Appendix K. Comment Letters and Responses on the Draft Environmental Impact Statement/ Environmental Impact Report

Subject: Comments on Draft Environmental Impact Statement/Environmental Impact Report for the Lower Elkhorn Basin Levee Setback Project (Corps File Number SPK-2016-00457), Yolo County, California

Figure 4.14-2b. Summary of Hydraulic Modeling Results by Alternative for Representative Index Points and 100- and 200-year Flood Events

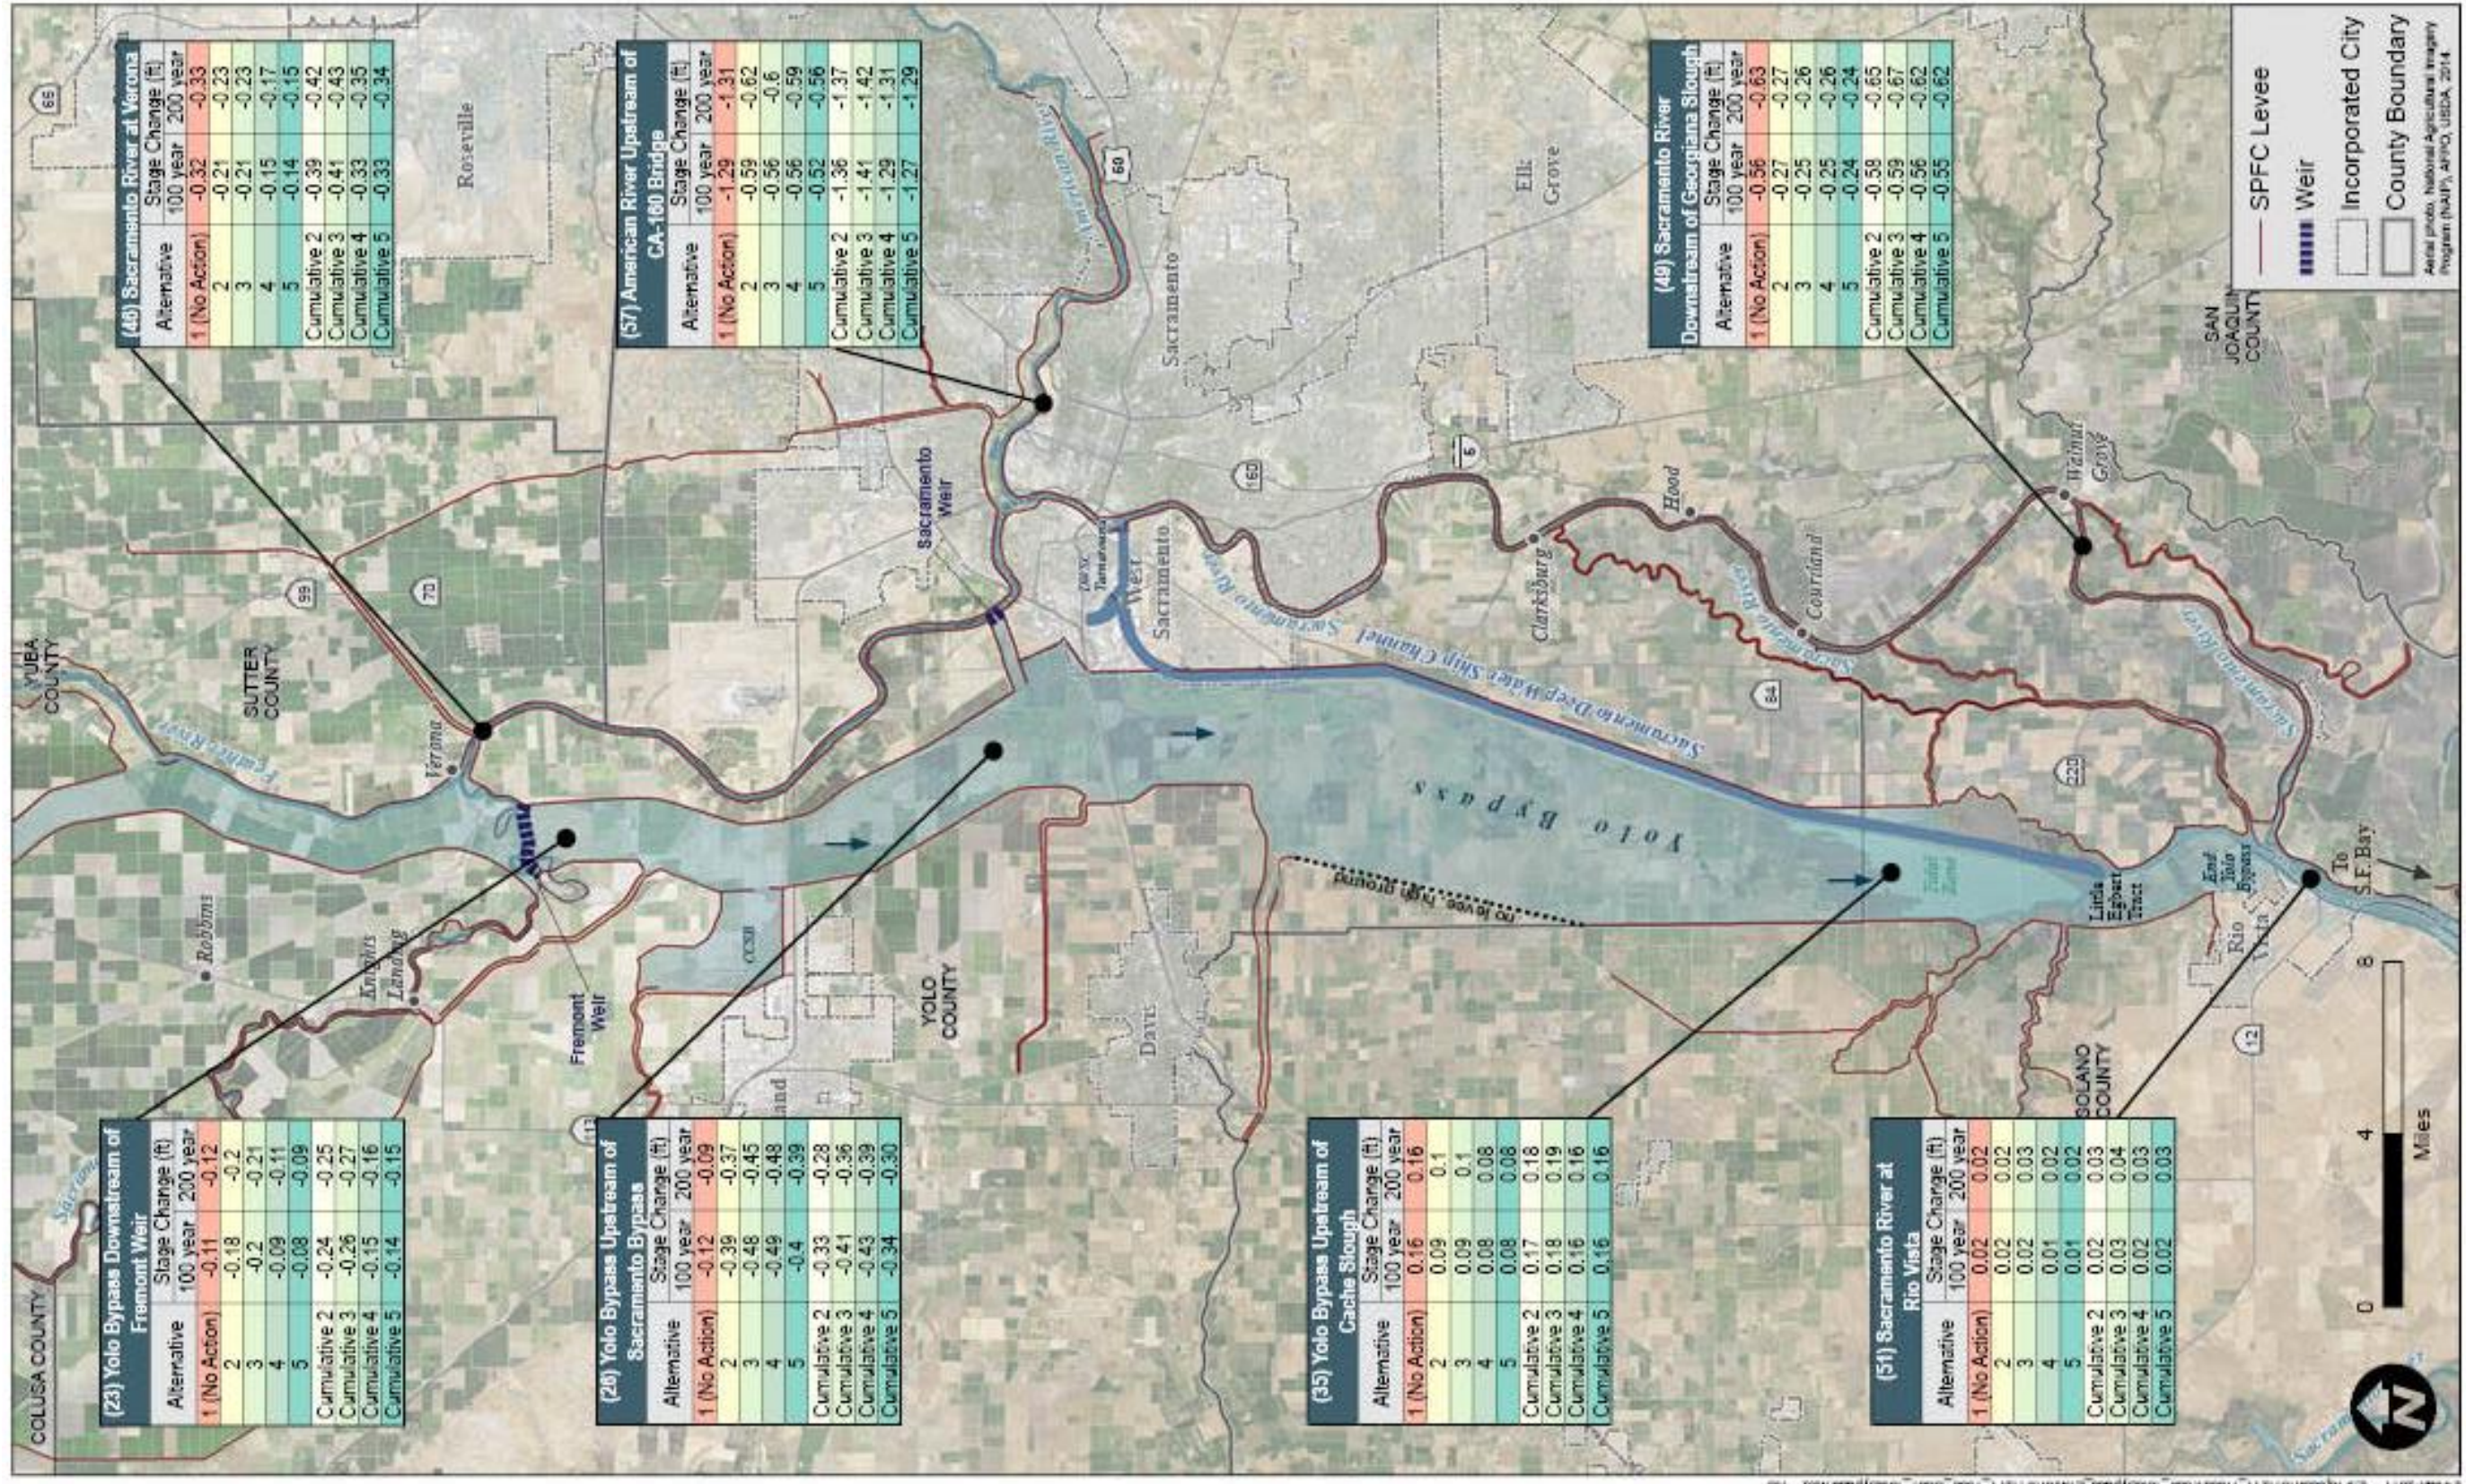
Clarify Flood Stage Reduction Comparisons - Figure 4.14-2a shows a reduction in flood stage for the No Action Alternative although the text states that the No Action Alternative is the same as the existing condition. The Final EIS/EIR needs to clarify what the reduction in flood stage for the existing condition is being compared to.

Page 4.14-13	Clarity needed regarding existing condition flood stage analysis	Figure 4.14-2a shows a reduction in flood stage for the No Action Alternative although the text states that the No Action Alternative is the same as the existing condition. The Final EIS/EIR needs to clarify what the reduction in flood stage for the existing condition is being compared to.	YOLO-34
--------------	--	--	---------

A reduction in flood stage is shown under the No Action Alternative in Figure 4.14-2 for a few reasons. For hydraulic modeling purposes, the *Existing Conditions* model scenario represents conditions in the system on the date the NOP was issued. However, the NEPA No Action Alternative is most accurately represented by the *Future Without-Project* hydraulic model scenario, which also includes the ARCF GRR Sacramento Bypass Levee Setback and Sacramento Weir widening to provide additional hydraulic

specificity since both the ARCF GRR and the project have the Sacramento Bypass Levee Setback as a common feature. The inclusion of these two ARCF GRR features and their respective changes to the overall flood system account for a reduced flood stage, for certain index points, under the No Action Alternative in Figure 4.14-2.

The stage reduction shown for the index points on Figure 4-14.2 for the No Action Alternative is a comparison between stage under Existing Conditions and stage under the Future Without-Project Conditions Scenario. This information shown for No Action in Figure 4-14.2 directly corresponds to the *Future Without-Project vs. Existing Conditions Change in Stage* column in Tables 4.14-3 and 4.14-4. This difference in stage is the result of the inclusion of the USACE American River Common Features General Reevaluation Report (ARCF GRR) recommended plan elements in the Future Without-Project Scenario

Page 4.14-18, Figure 4.14-2b is revised as follows:
